DEVELOPMENT ASSESSMENT REPORT				
Application No.	DA/2022/0301			
Address	12 Foucart Street ROZELLE			
Proposal	Demolition of existing structures and construction of dual occupancy with strata subdivision			
Date of Lodgement	2 May 2022			
Applicant	Monument Plan Pty Ltd			
Owner	Miss Deana Mourad			
Number of Submissions	Initial: 6 After Renotification: 7 Total Unique Submissions: 8			
Value of works	\$633,000.00			
Reason for determination at Planning Panel	Variation to FSR development standard exceeds 10%			
Main Issues	<ul style="list-style-type: none"> • Permissibility under <i>Inner West LEP 2022</i> • Breaches all applicable development standards • Demolition of a contributory dwelling • Amenity impacts to neighbours • Loss of on-street parking 			
Recommendation	Refusal			
Attachment A	Reasons for Refusal			
Attachment B	Plans of proposed development			
Attachment C	Section 4.6 Exception to Development Standards - FSR

This report is an assessment of the application submitted to Council for the demolition of existing structures and construction of a dual occupancy with strata subdivision at 12 Foucart Street Rozelle. The application was notified to surrounding properties an

Shadow Diagram Proposed
 Drawing title
 Project No. DA 20
 Lot area 254.83m²
 Client Mouned

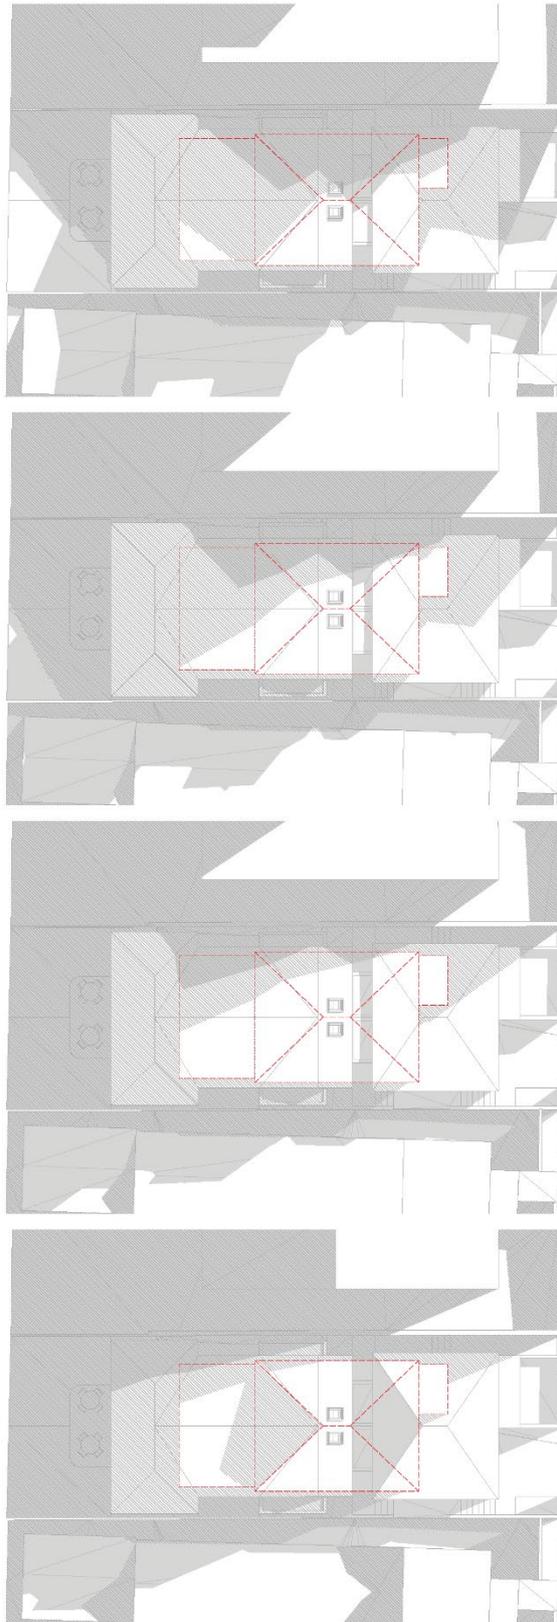
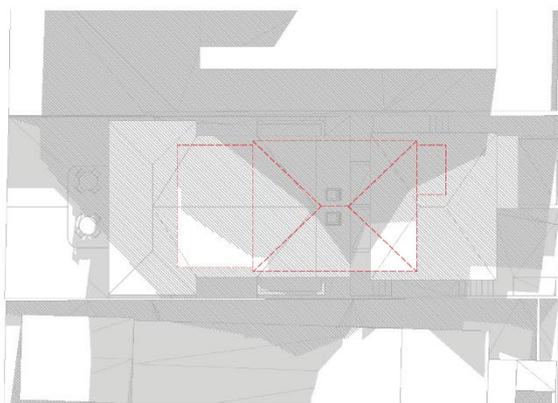
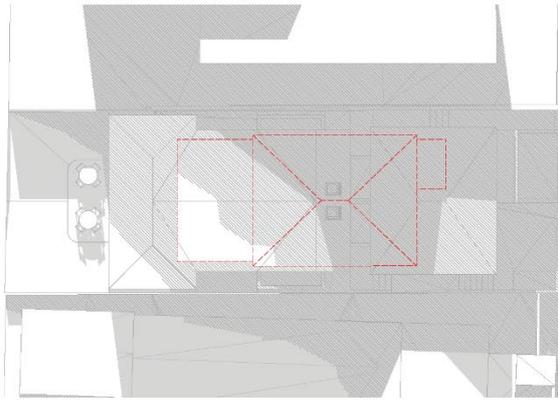
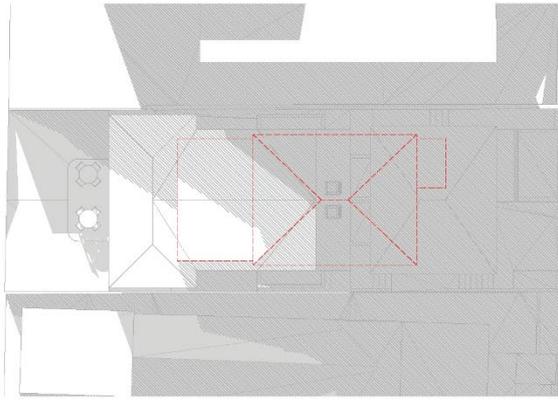
The solar access diagrams demonstrate that although the proposed dwelling on Lot B (northern-most allotment) may receive sufficient solar access to internal and external living areas (between 12pm and 3pm), the proposal will provide non-compliant solar access to both the rear private open space and the internal living area of the southern property proposed on Lot A.
